To: T10 Technical Committee

From : Jim Reif

Subject: SAS Bit Ordering Diagrams Change Proposal

Figure 35 – SAS bit transmission logic

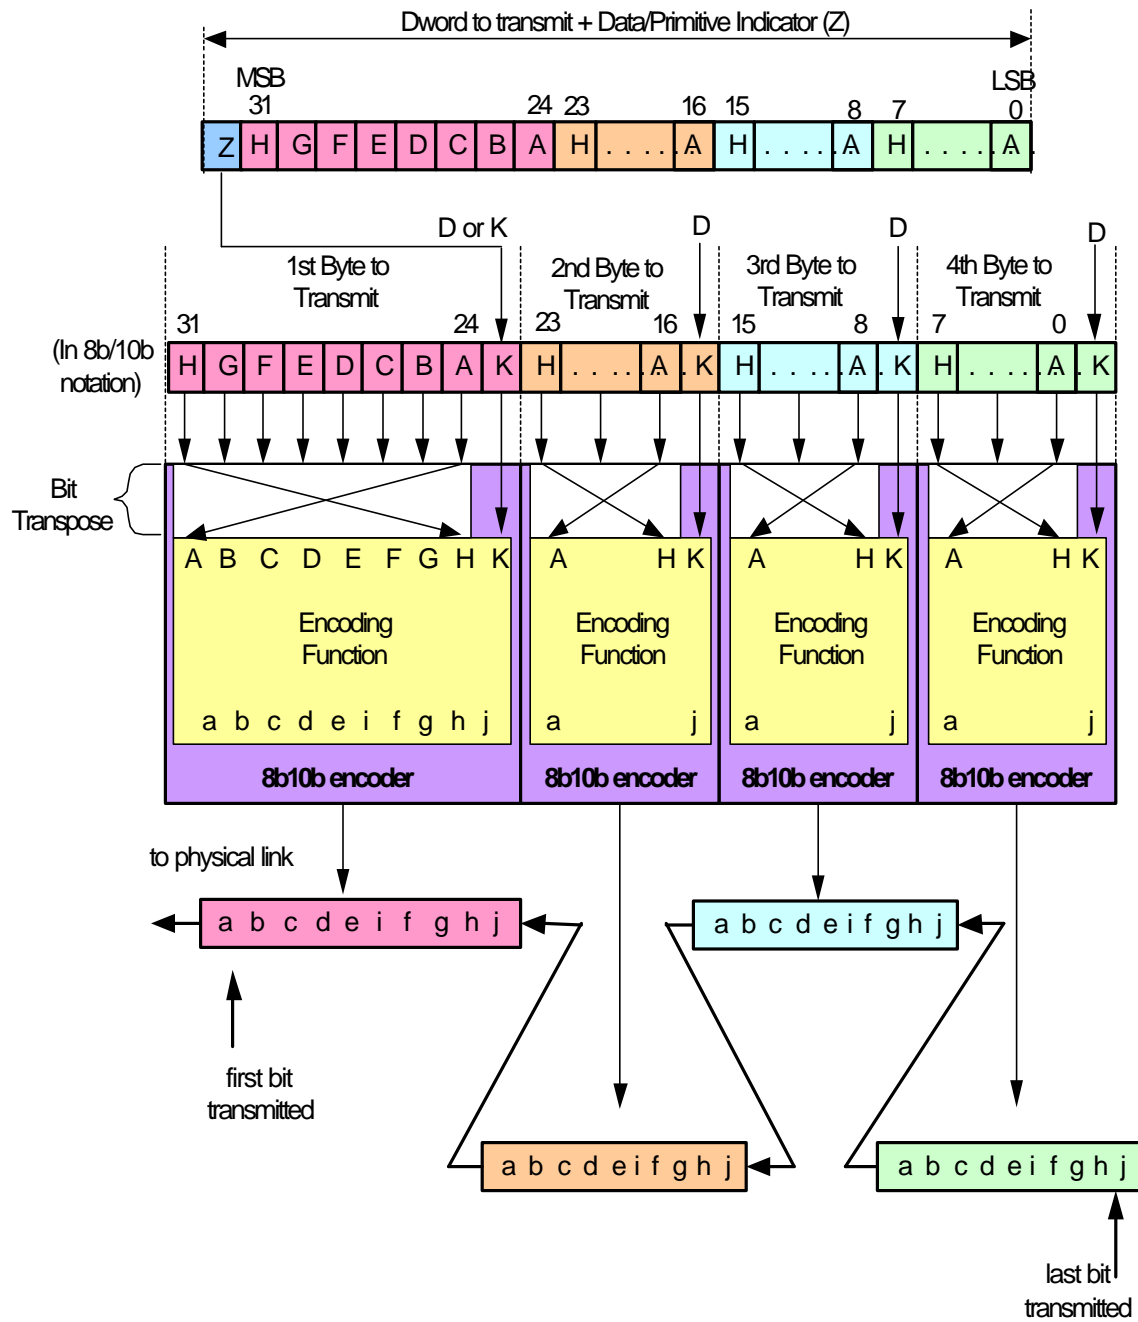
Figures 35 and 36 in sas-r02a show bit transposition logic required *prior* to 8b/10b encoding and *after* 10b/8b decoding. While bit transposition within a byte is actually required for 8b/10b encoding and decoding as defined by the original 8b/10b encoding patent, the bit transposition is done *inside of* the 8b/10b encoder and 10b/8b decoder, *not outside of* the them, as depicted in the current figures. This document proposes a modification to Figures 35 and 36 in order to better correlate them to Tables 22 and 24, as well as to show that one does not have to perform a bit transposition on an 8-bit value prior to looking up the associated 10b encoding in Table 24.

1) Figures 35 and 36 show bit transposition being done within each byte of a dword outside of the 8b/10 encoding/decoding logic. Propose that these diagrams get replaced with the following diagrams:

Figure 55 – SSP/SMP CRC generator/checker byte and bit order

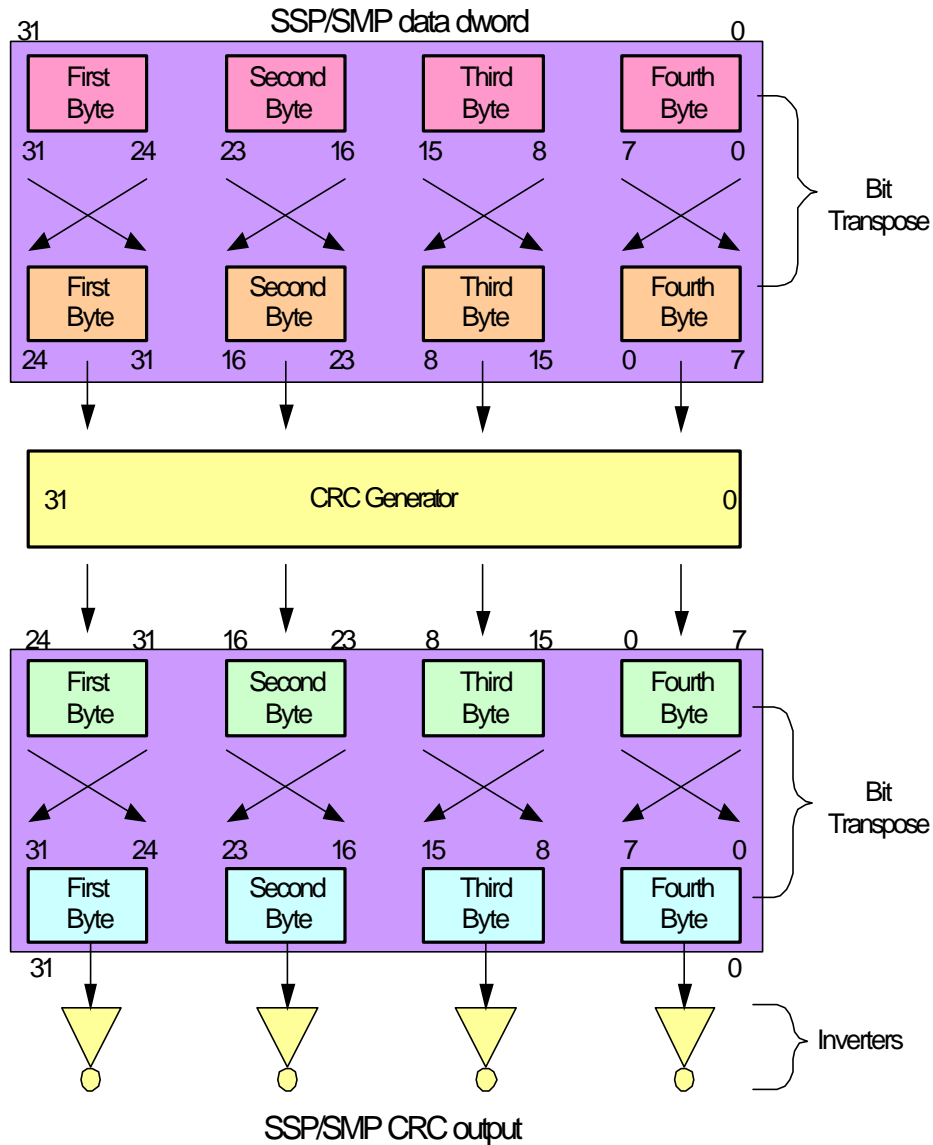
2) Figure 55 is missing bit inversion at the output of the CRC generator. Propose to replace with the following figure which shows the outputs being inverted, and shows the bit ordering within each byte:

Figure 56 – SSP/SMP Transmit path byte and bit ordering

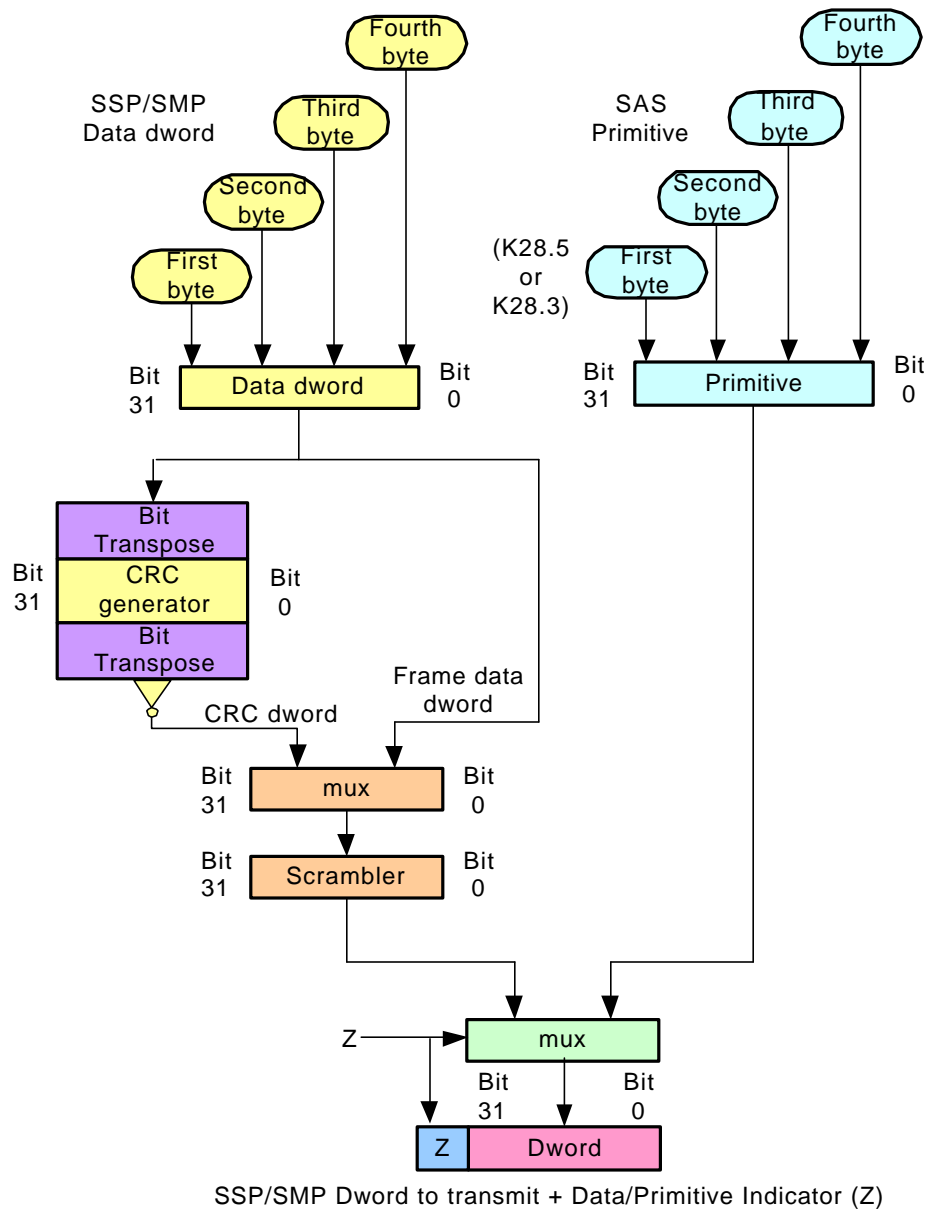
3) Figures 56 and 57 do not show the bit transposition and inversion logic associated with the SSP/SMP CRC generator/checker. Propose to replace with the following figures:

Figure XX - STP CRC generator/checker byte and bit ordering

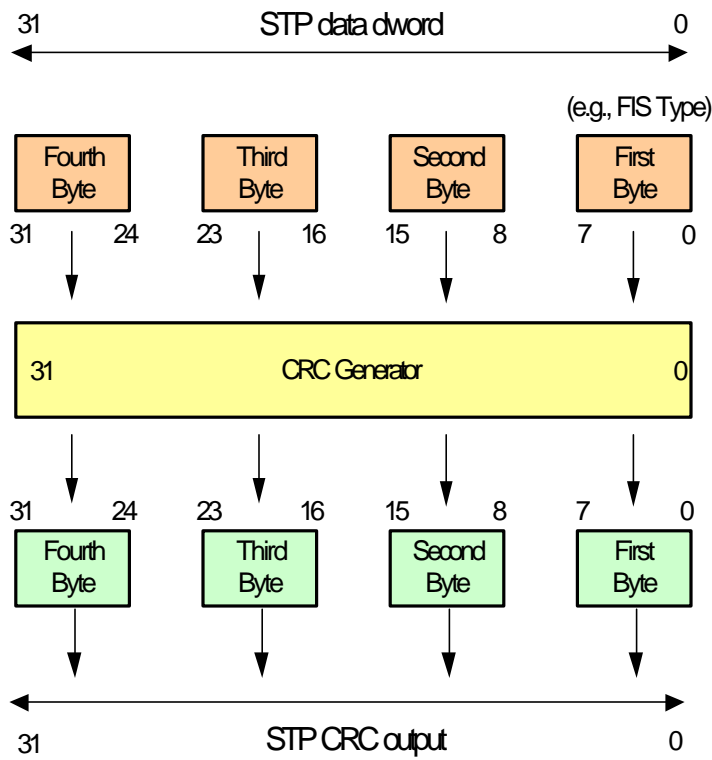
4) Propose that three diagrams be added *to the Appendix* to clarify the byte ordering for STP data paths and the difference between SSP, SMP and STP CRC requirements.
